City of Portland, Maine - Building or Use Permit Application

Permit No: 01-1083	Issue Date: SEP-7	CBL: 339 J021001
-----------------------	----------------------	---------------------

Past Use: single family	Proposed Use: single family with 16' x 20' addition with 5' x 20' front porch attached and relocating shed	Permit Fee:	Cost of Work: \$0.00	CEO District: 1
Proposed Project Description: 16' x 20' addition with 5' x 20' front porch attached and relocating shed		FIRE DEPT: <input type="checkbox"/> Approved <input type="checkbox"/> Denied N/A	INSPECTION: Use Group: 6R-3 Type: 5B BOCA 1999 Signature: <i>T. Munson</i>	
		PEDESTRIAN ACTIVITIES DISTRICT (P.A.D.) Action: <input type="checkbox"/> Approved <input type="checkbox"/> Approved w/Conditions <input type="checkbox"/> Denied Signature: <i>N/A</i> Date:

RE: SELLECK PROJECT

FLOOR SPAN TABLES

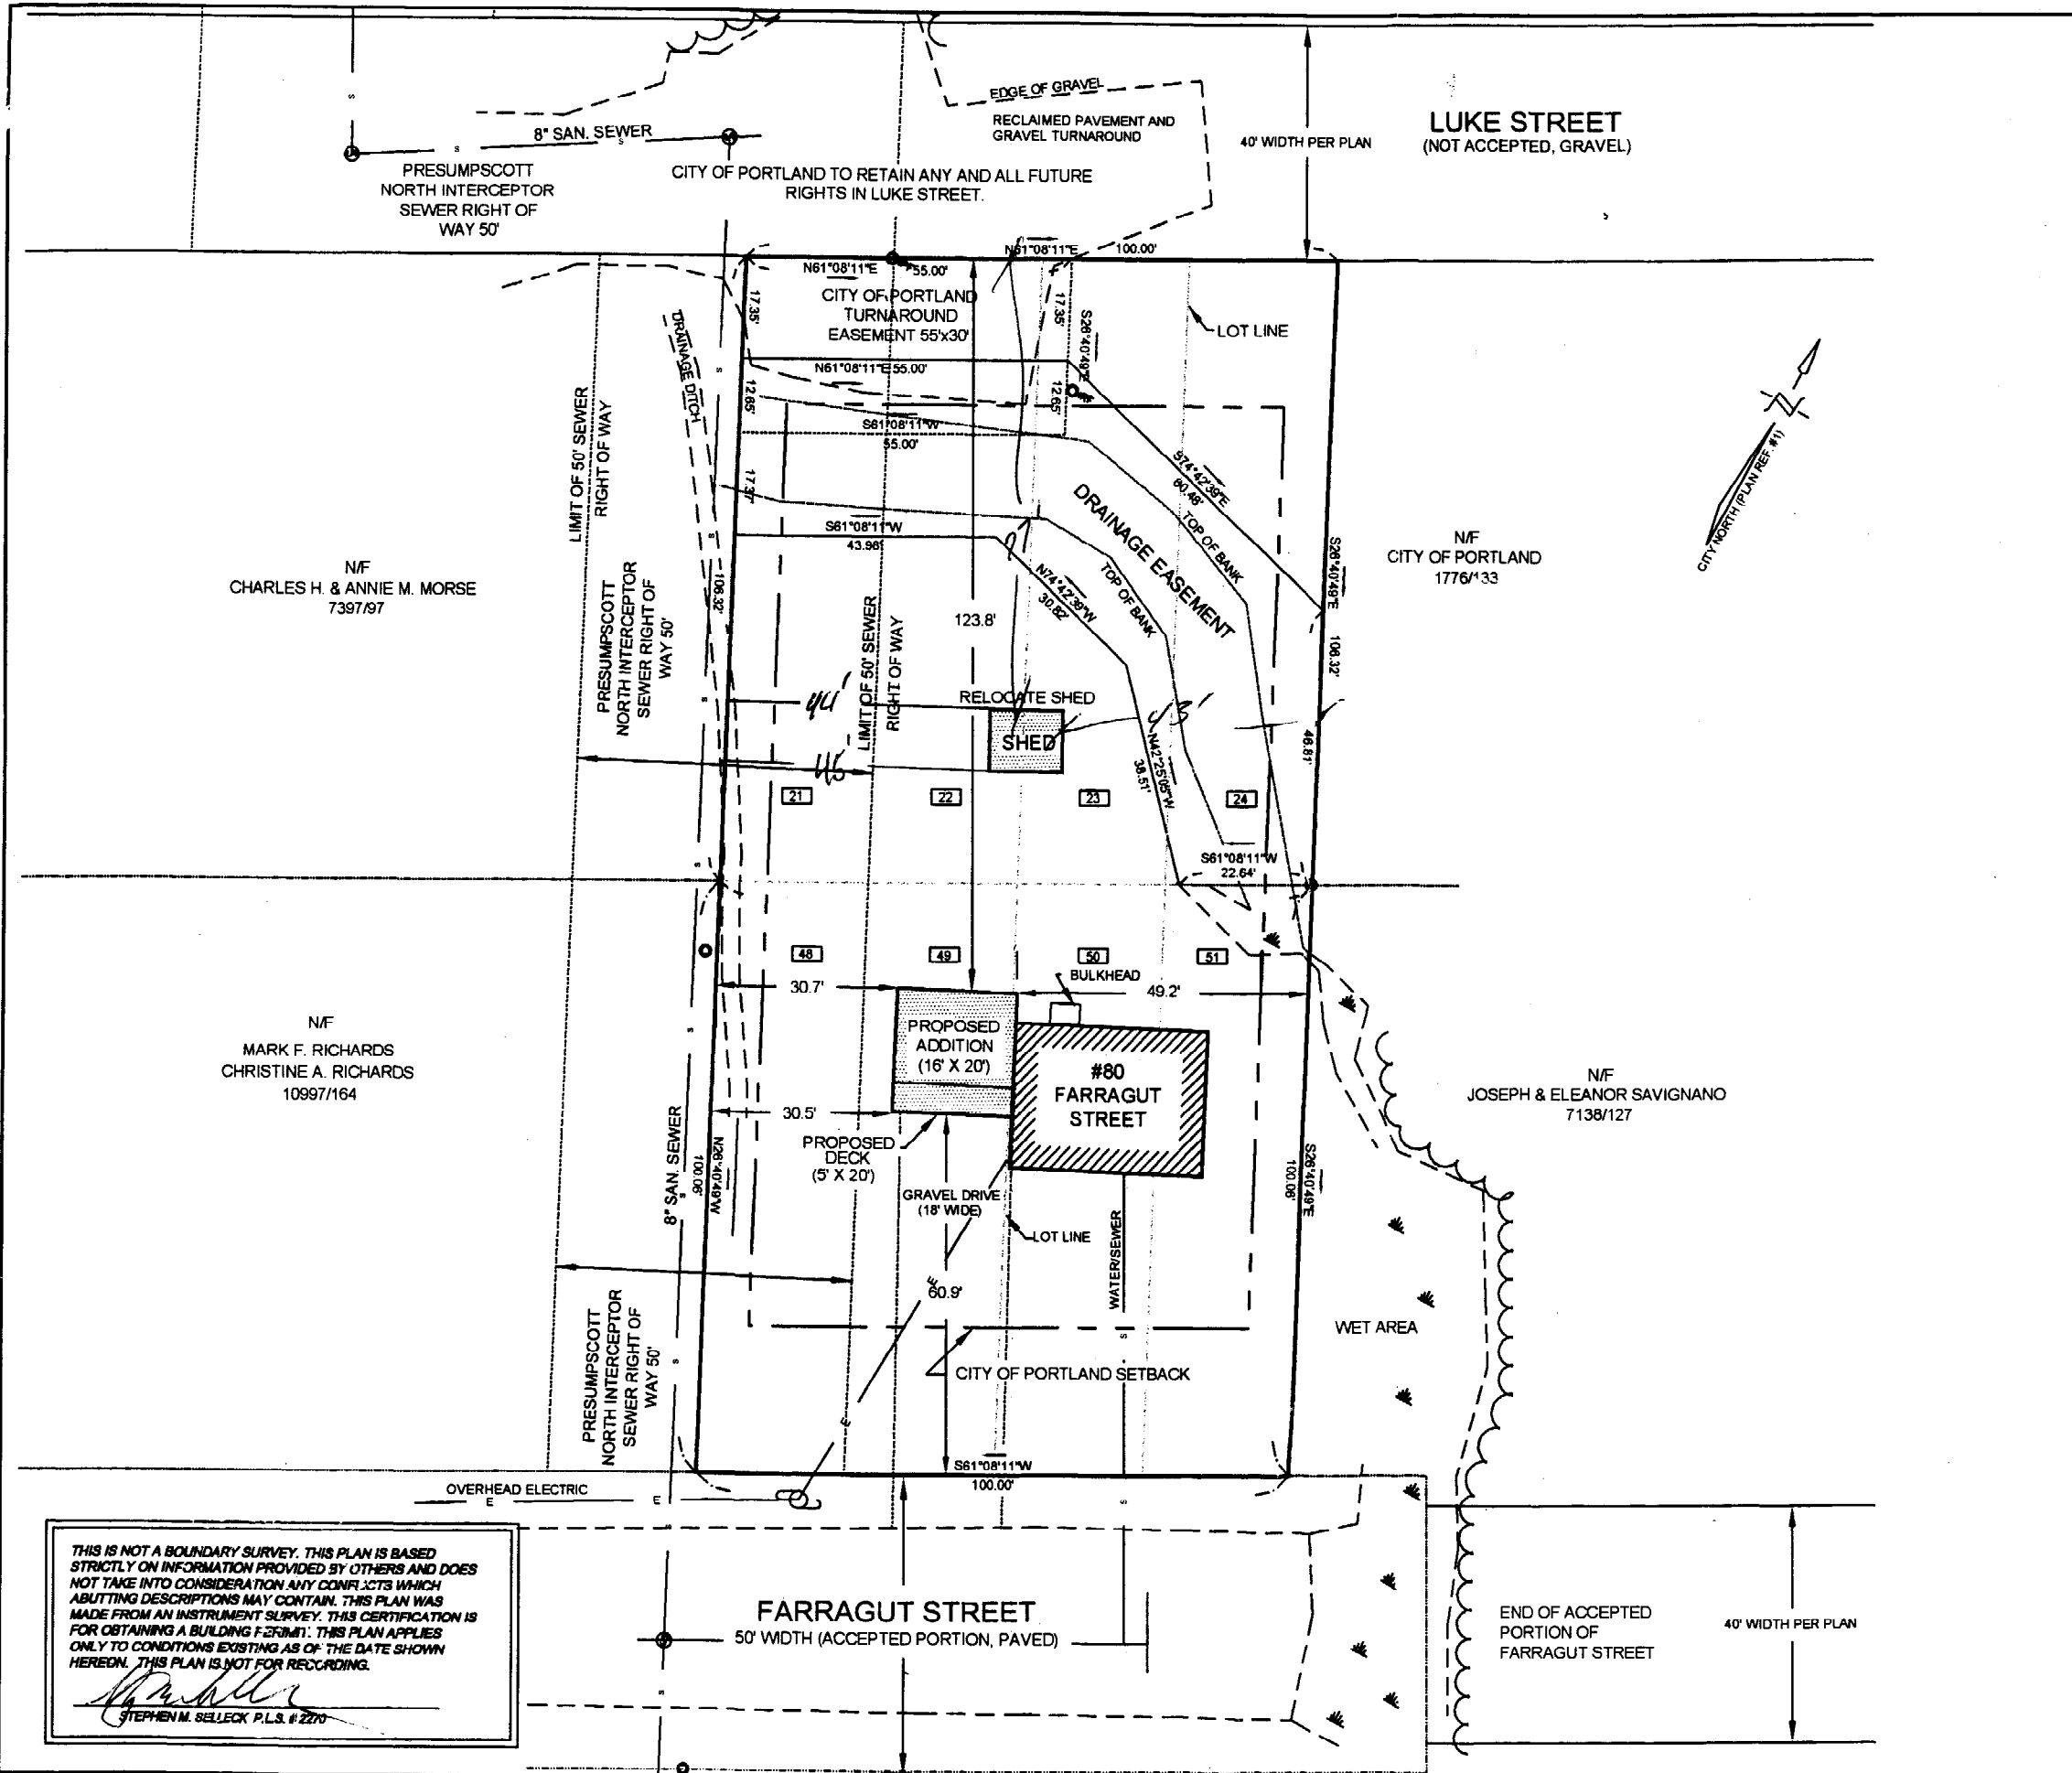
TAMMY; ENCLOSED IS A SPEC SHEET PROVIDED BY TRUS JOIST
MACMILLAN; DEPTH = 9 1/2"

LOAD = 40 P.S.F. LIVE 10 P.S.F. DEAD
MAX SPAN = 17'-10" (OUR SPAN IS 15'-6")

HEADERS ARE 2 X 10 WITH 1/2" PLYWOOD BETWEEN
BAY WINDOW HEADER IS 2 X 12 WITH 1/2" PLYWOOD BETWEEN.

SKETCH PLAN
 80 FARRAGUT STREET PORTLAND, MAINE

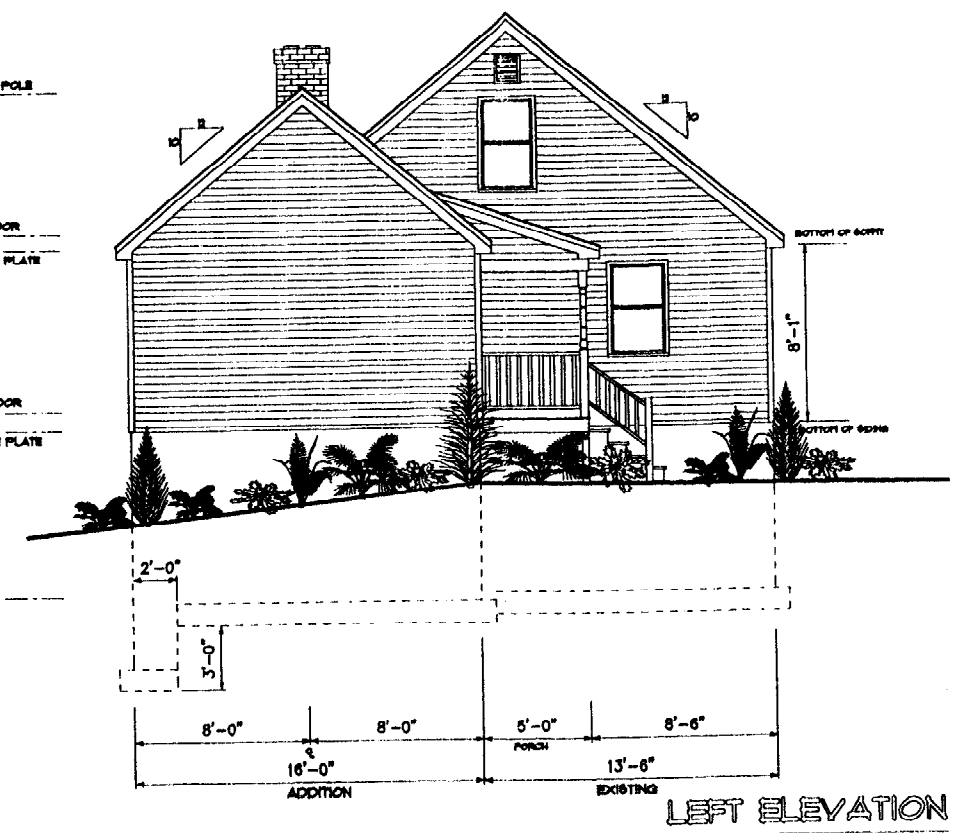
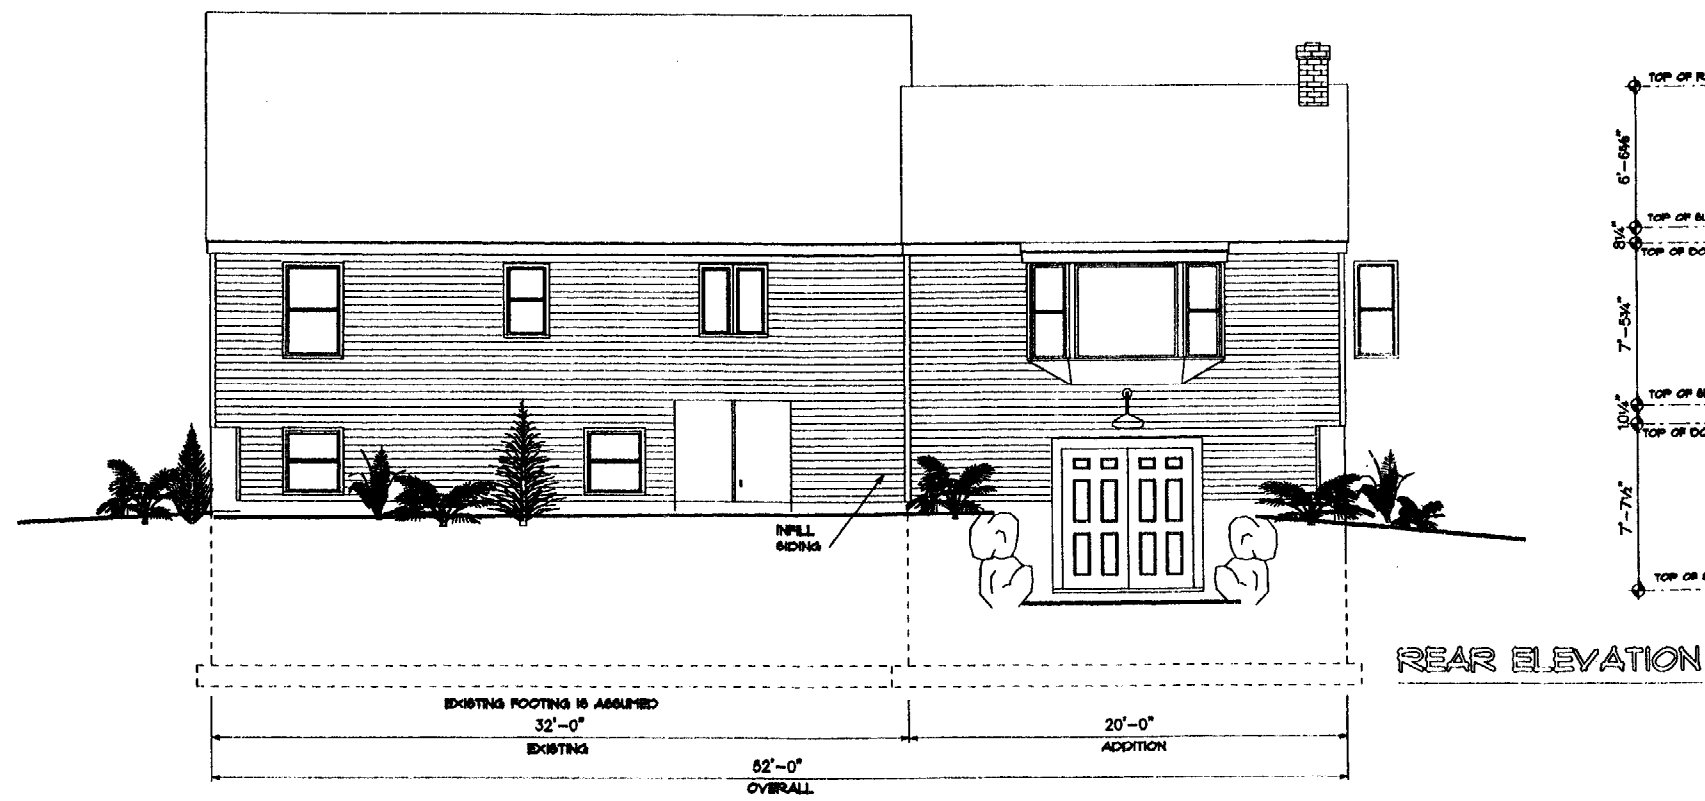
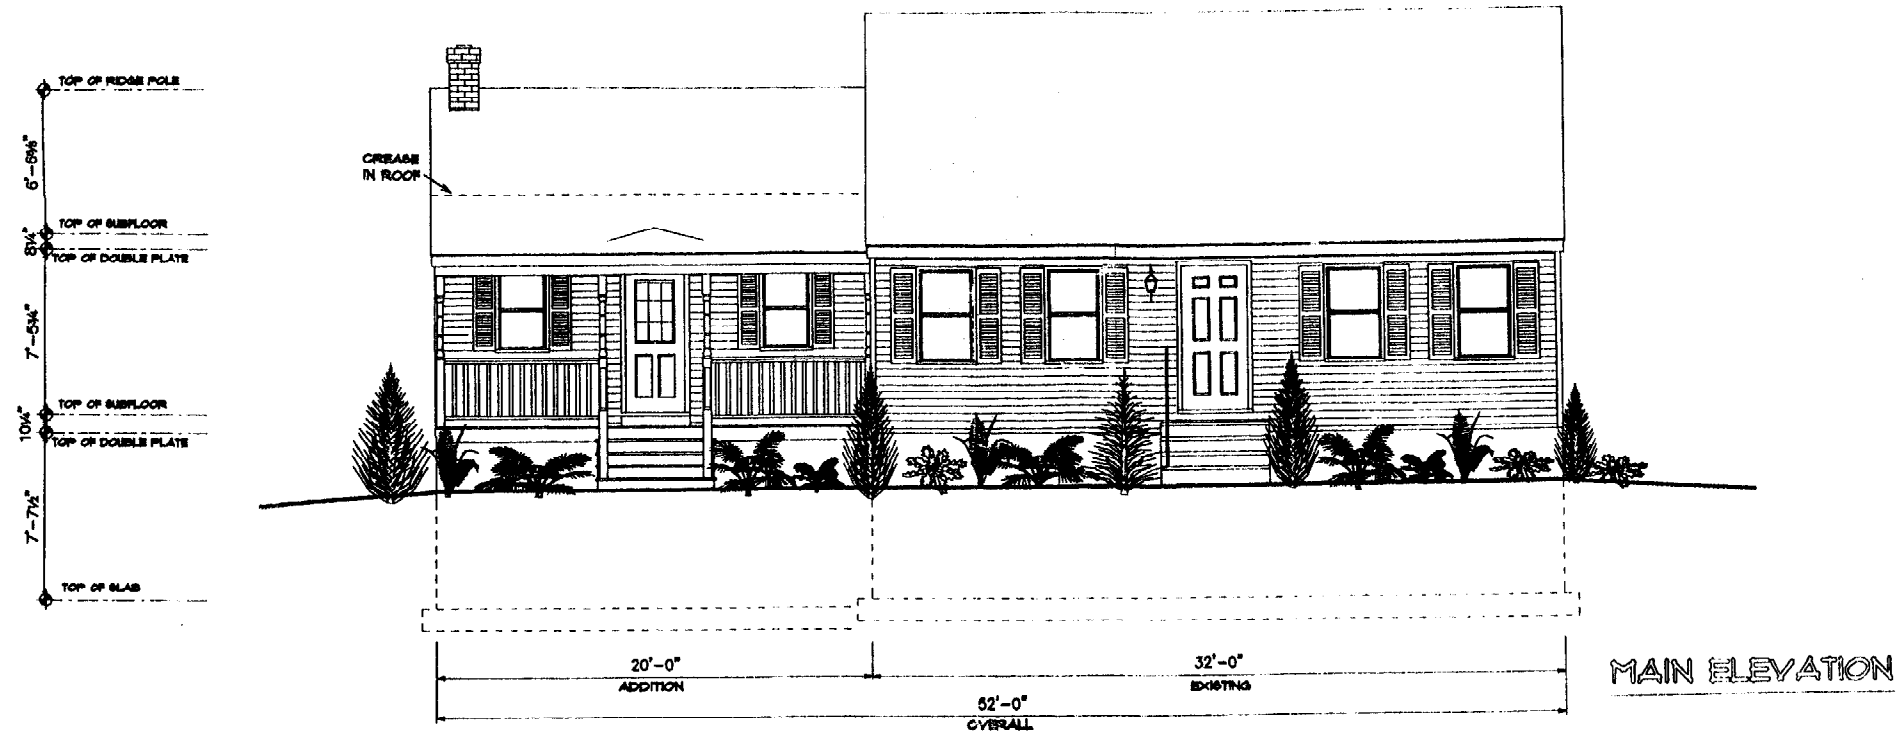
Front Yard - 60.9' shown (25 Req) - OK

Rear Yard - 123.8' shown (addition) - 12' Req - OK
77' shown (shed)

Side Yard - 30.5' shown - 8' Req - OK

Projections - 44 = 43' shown - OK
